Red-Line Revision 1

MD 146 (Dulaney Valley Road) @ Fairmount Avenue

TRAFFIC SIGNAL PLAN

TS NO. 1927D DRAWING - OF SHEET NO. 1 OF 4

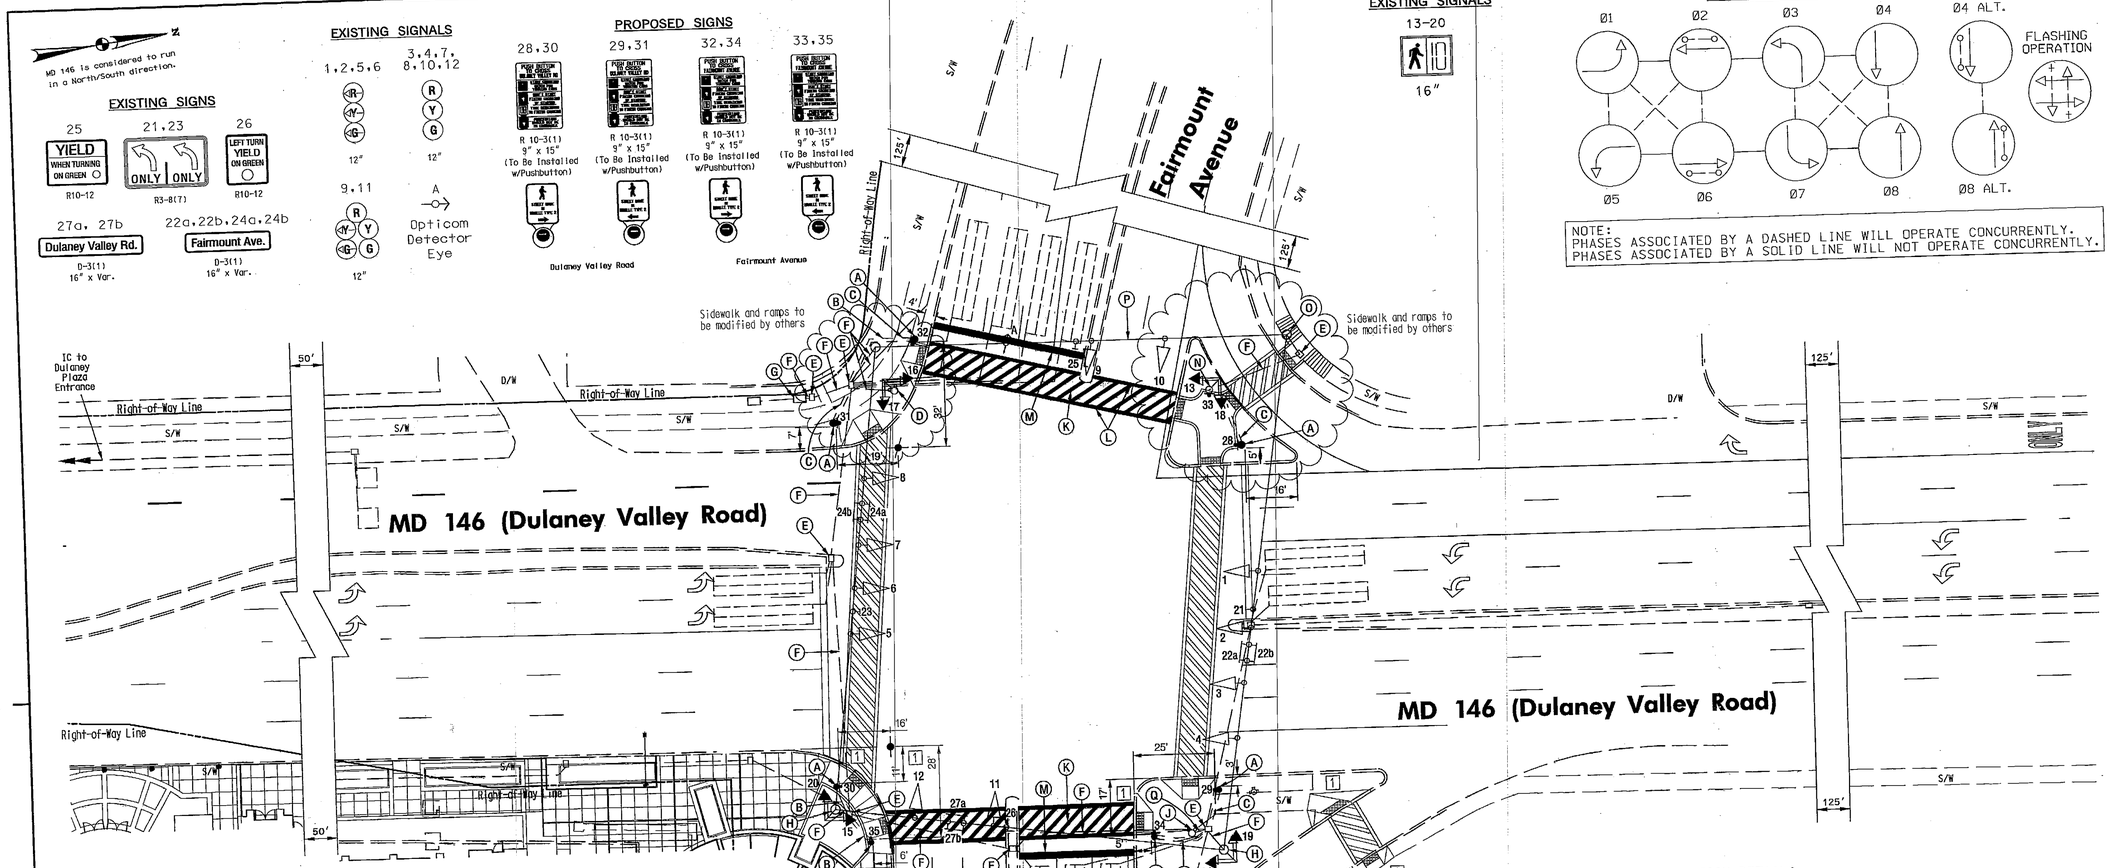
1	Redline Revision revised sidewalk and ramps	011409
D	Remove existing ped. install APS indications SHA No.: BW96M82	6/5/07
C	Installing Opticom SHA No.: BA563A/B82	4/25/06
